CONDITIONAL BUILDING REGULATION APPROVAL REPORT

**FORM 3 NEW FLATS AND RENOVATION OF EXISTING
COMMERCIAL UNITS**

**7 AND 9 WERN ROAD, YSTALYFERA, NEATH AND PORT
TALBOT, SA9 2LX**

REFERENCE: SA61663

Section 3

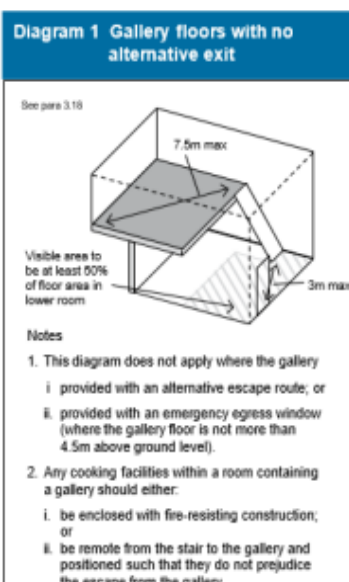
5. **Internal flat layouts** – Flat no 2 to be designed with means of escape windows to first floor habitable rooms with independent entrance and a gallery room is proposed. See guidance below

3.8 A gallery should be provided with an alternative exit; or, where the gallery floor is not more than 4.5m above ground level, an emergency egress window which complies with paragraph 3.9. Where the gallery floor is not provided with an alternative exit or escape window, it should comply with the following:

- a. the gallery should overlook at least 50% of the room below (see Diagram1);
- b. the distance between the foot of the access stair to the gallery and the door to the room containing the gallery should not exceed 3m;

- c. the distance from the head of the access stair to any point on the gallery should not exceed 7.5m; and
- d. any cooking facilities within a room containing a gallery should either:
 - i. be enclosed with fire-resisting construction; or
 - ii. be remote from the stair to the gallery and positioned such that they do not prejudice the escape from the gallery.
